Applicant: Eiji Nishibe et al. Attorney's Docket No.: 10417-103001 / F51-139075M/SW

Serial No.: 10/007,384

REMARKS

Page 5 of 5 Appl. No.: 10/007,384 Amendment in Reply to Office action of April 22, 2003 Replacement Sheet

FIG.9

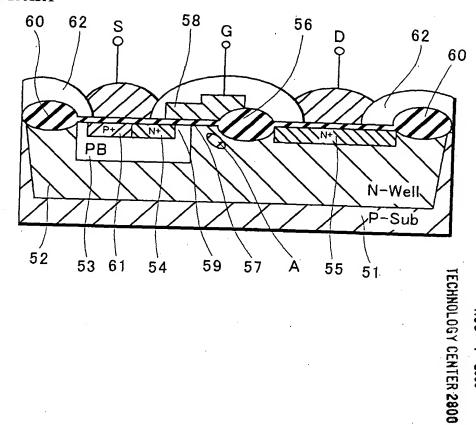
Figure 9 on drawing sheet 5 has been amended to include the legend "Prior Art." A replacement drawing sheet is attached hereto.

PRIOR ART
